### FIELD ENGINEERING BULLETIN

TITLE: VS-10 Causes Occasional Servo Instability

REF. NO. 70202

MODEL VS-10

Figure 1.

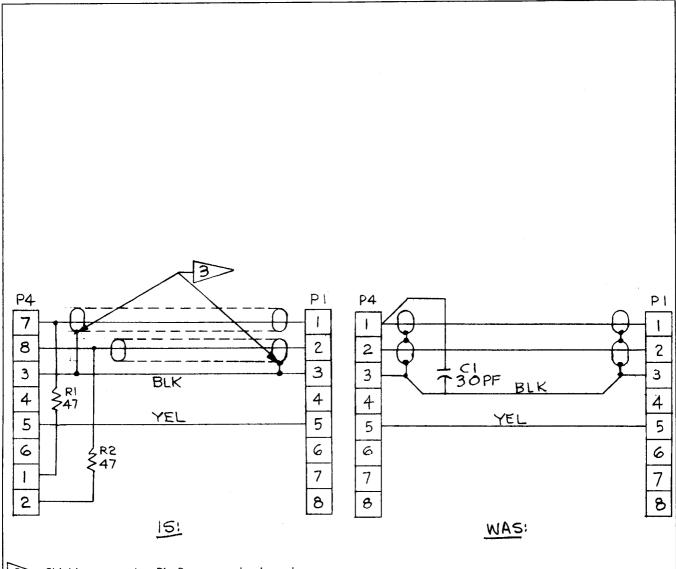
Early VS-10 interconnect cables caused capstan servo instability occasionally. This modification completely eliminates the problem.

The existing interconnect cable must be rewired using existing wiring in the harness. A capacitor is removed from the connector shell and two resistors are substituted.

- 1) Remove and discard capacitor C1 (30PF) from PINS 1 and 3 of P4.
- 2) Remove wire on P4-1 and move to P4-7 as shown in fig. 1.
- 3) Remove wire on P4-2 and move to P4-8 as shown in fig. 1.
- 4) Add 2 resistors R1 and R2 (47 OHM, 1/4W, 5%) P/N 041-425 to P-4 as shown in fig. 1.
- 5) The harness shielding will attach at one end only.

3 Shield connected to Pin 3 at one end only as shown.
